SAFETY ALERT

StingSport Nose Gear Strut Inspection

NOTICE ID: TL091507-Rev1

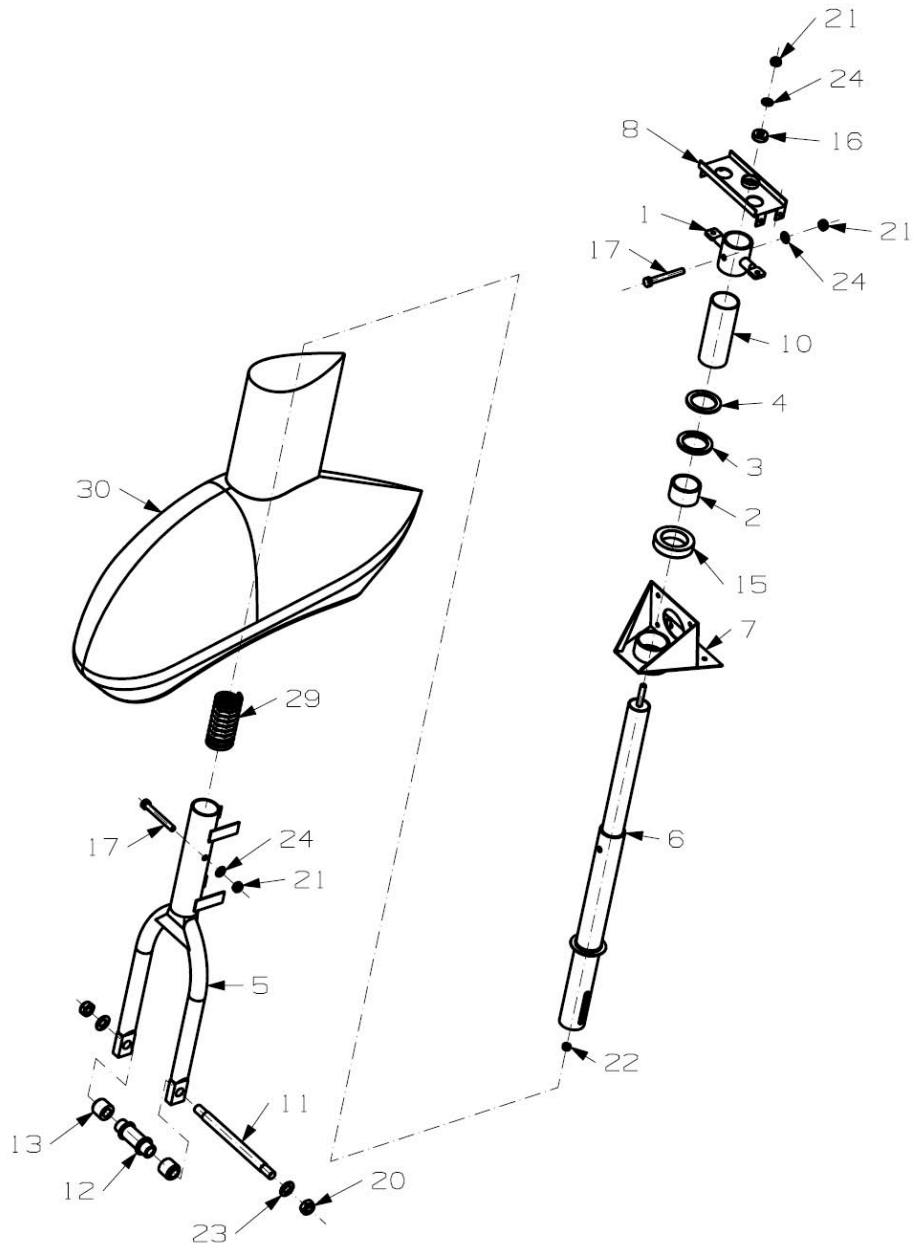
Description of the assembly: The lower nose wheel fork (Item 5 in the illustration below) and wheel/tire assembly attaches to the upper nose gear strut-tube (Item 6 in the illustration below) by a single bolt (Item 17 in the illustration below). This bolt aligns the upper and lower nose gear tubes and retains the spring (Item 29 in the illustration below) which is compressed from above by the lower end of the upper nose gear strut and contained by the lower nose gear yoke tube.

The bolt functions to retain the alignment of the centerline of the lower nose wheel fork (therefore the nose wheel/tire assembly) and the upper nose gear strut (item 6 in the illustration below) which is connected to the push rods attached to the rudder pedals.

1. The area of this inspection is primarily the upper and lower portions of the machined slot in the lower part of the strut. This slot should be examined in detail while on the aircraft after removal of the lower nose gear fork and wheel assembly. Replace the nose gear strut if there is any sign of cracks radiating from the slot or other indications of metal stress.
2. Also inspect the top edge of the nose wheel fork (Item 5 in the illustration below) as it exits the top of the nose wheel fairing (Item 30 in the illustration below). This steel tube should have vertical straight edges and should be round and concentric. There should not be signs of metal stress such as "belled-out" edges or an elliptical shape at the top of this tube. Replace the nose wheel fork if signs of metal stress are present.
3. Make a log entry of this inspection in the aircraft records.
